Owner Change Order

Change Order Number: 003

City of Norman - North Base Complex Phase 1
1310-1380 DA Vinci Street
Norman, Oklahoma 73069

The Contract is hereby revised by the following items:

DRAWING NO.
E3-01

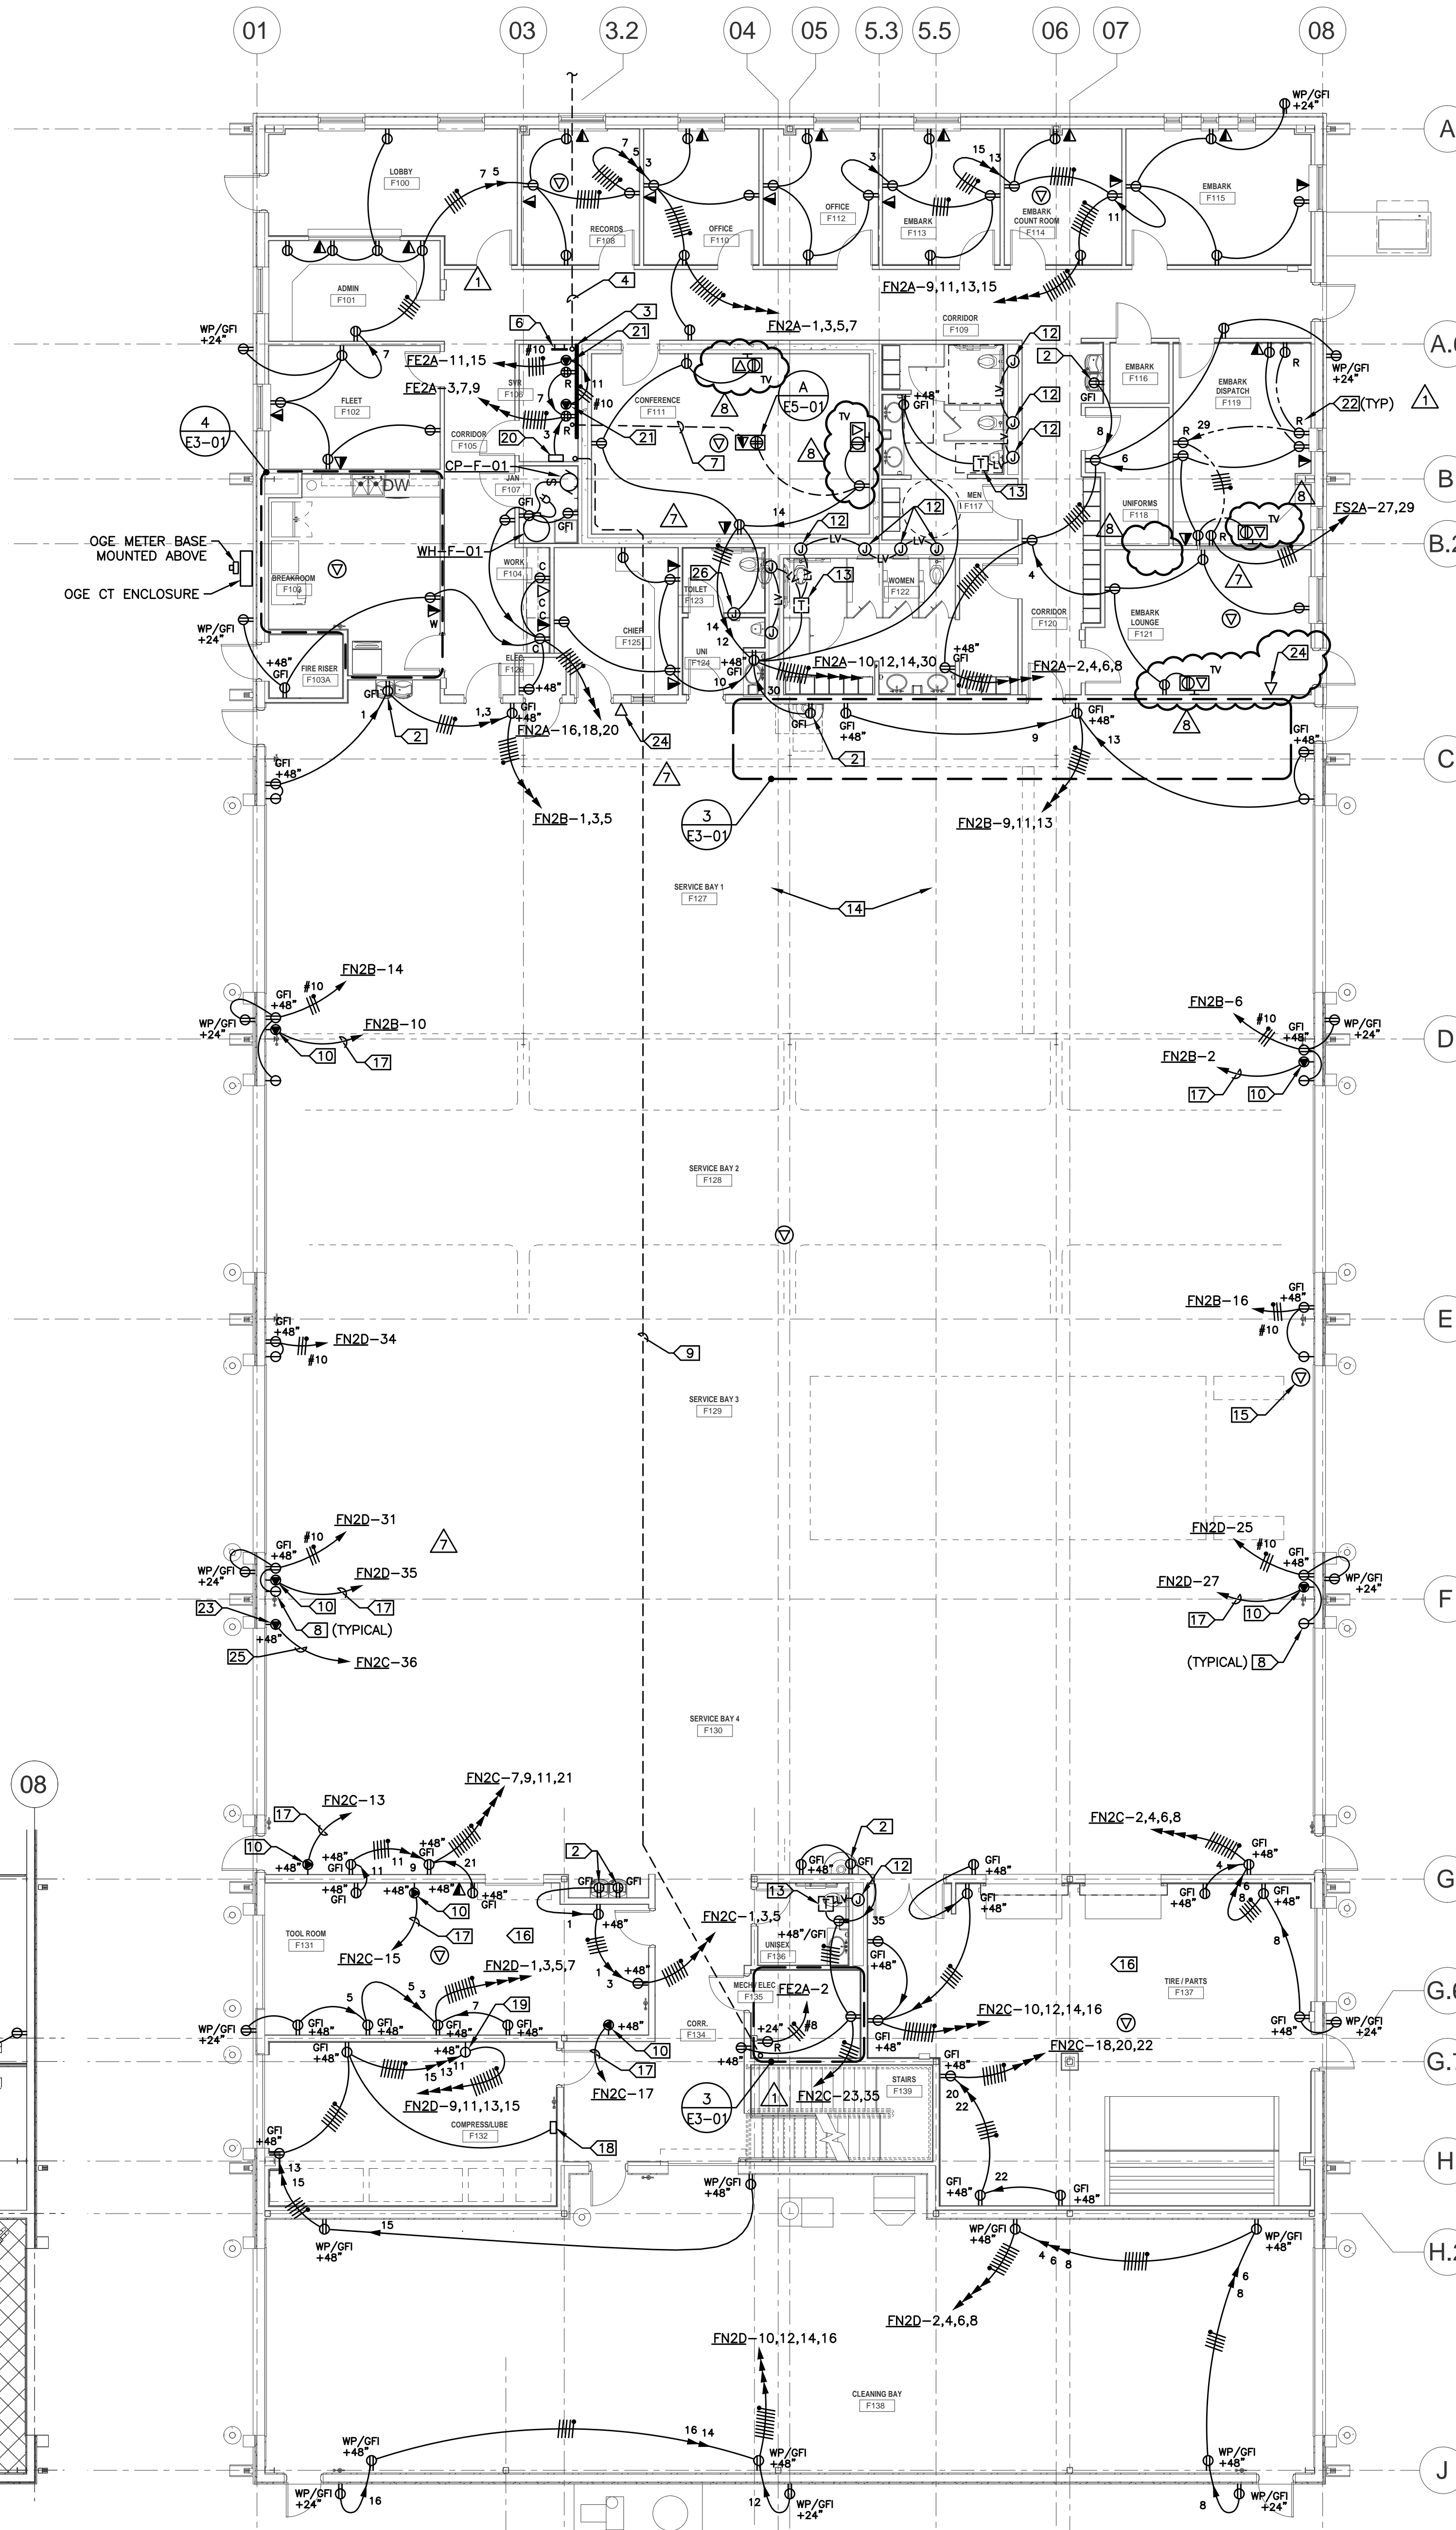
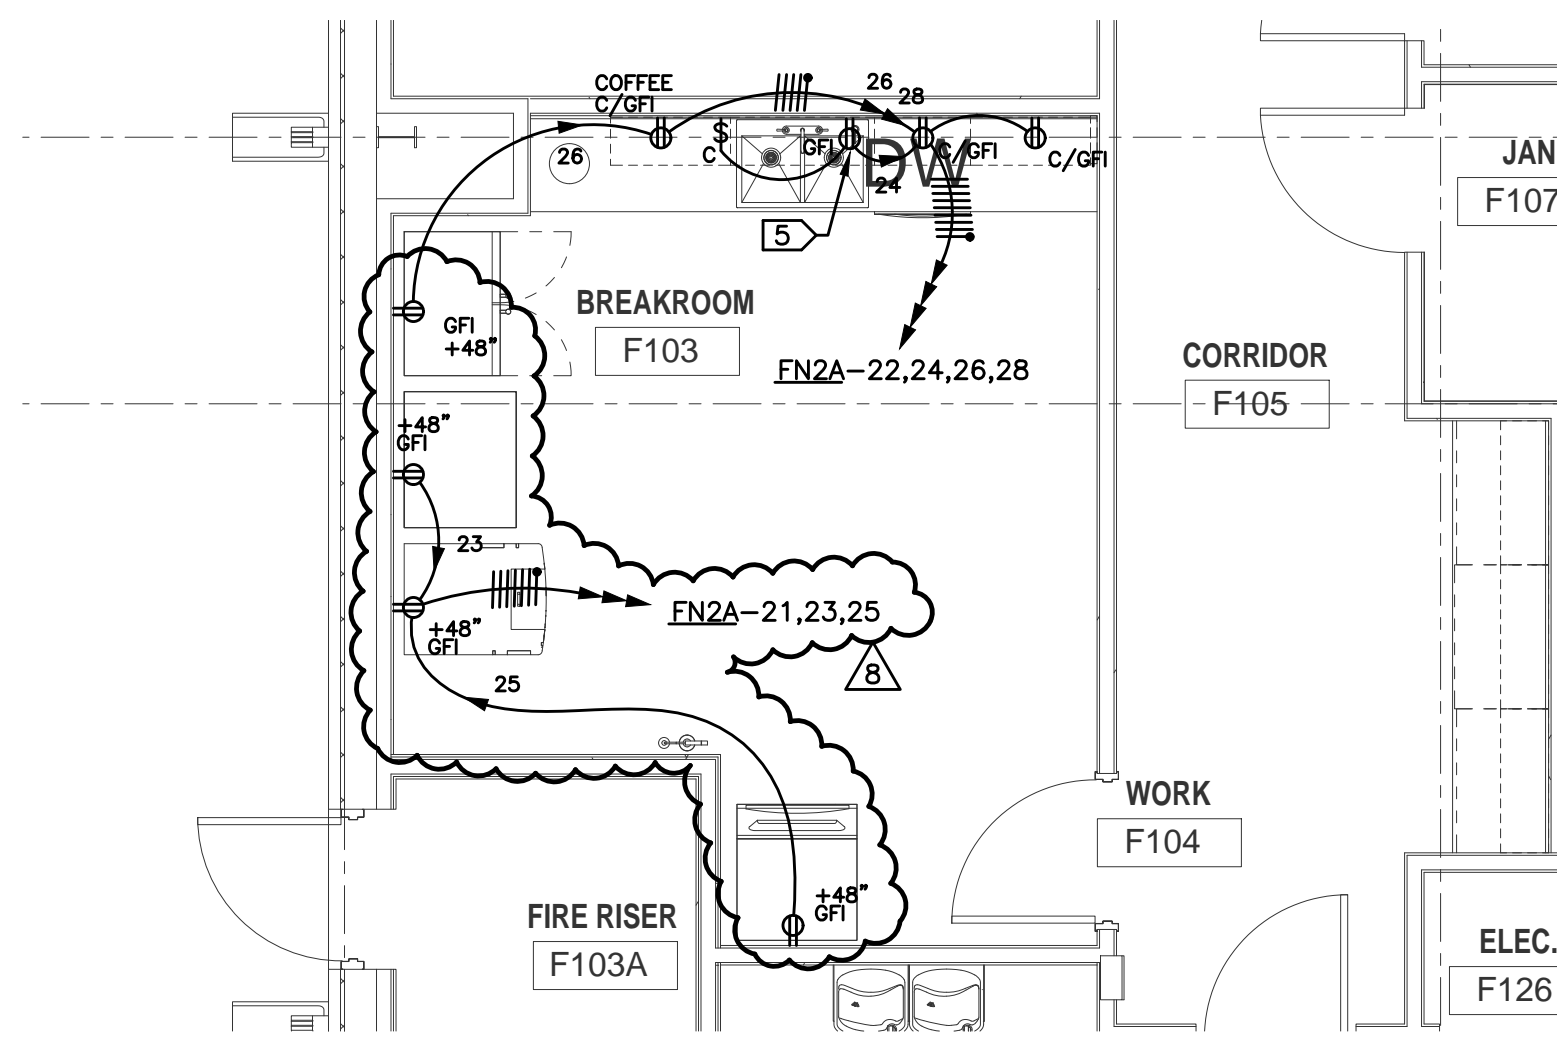
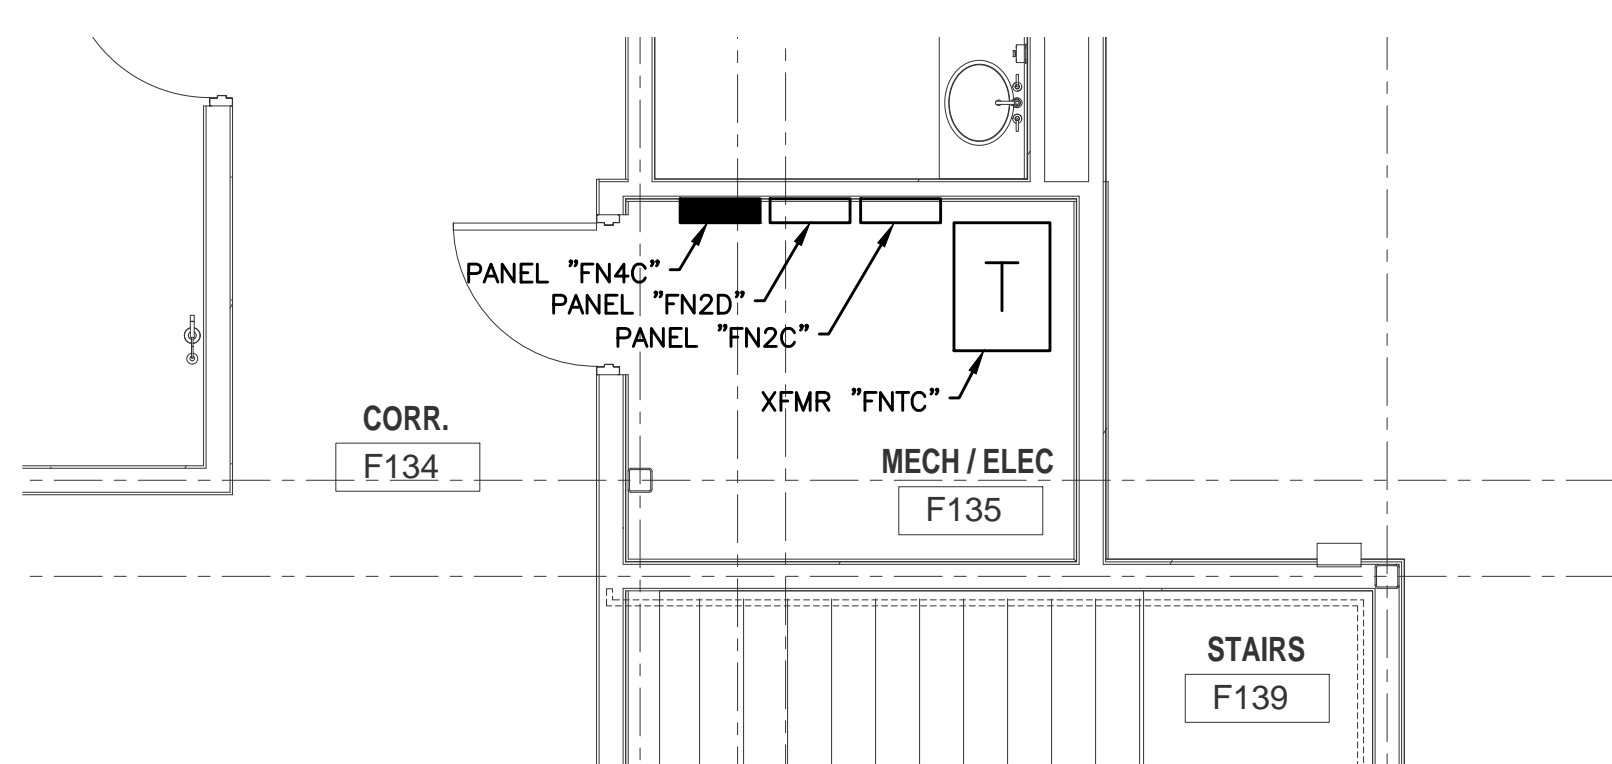
Item	Qty	Unit	Description	Labor Hours	Ext	Material	Ext	Open	Ext
1			added total of 2 tv/power boxes						
2			added 3 GFI receipts in break room						
3			added 3 circuits to brek room						
4			added 1 data rough in lounge						
5									
6	2	e	hubell tv/power rough in boxes			215.00	430.00		
7	2	e	10' sticks of 3/4" emt for data			12.50	25.00		
8									
9	3	e	GFI's			15.00	45.00		
10	7.5	e	10' sticks of 3/4" emt for FN2A 21,23,25			12.50	93.75		
11	1	e	3/4" seal off			25.00	25.00		
12	525	e	75' x 7 of #12 thhn			0.25	131.25		
13	4	e	4sqr boxes			5.00	20.00		
14									
15	1	e	10' stick of 3/4" emt for data rough			12.50	12.50		
16									
17	11	e	11 hours 1 man labor	1	11.00				
18									
19									
20									
21									
22									
23									
24									
25									
26									
27									
28									
29									
30									
31									
32									
Totals				1	11.00		782.50		0.00
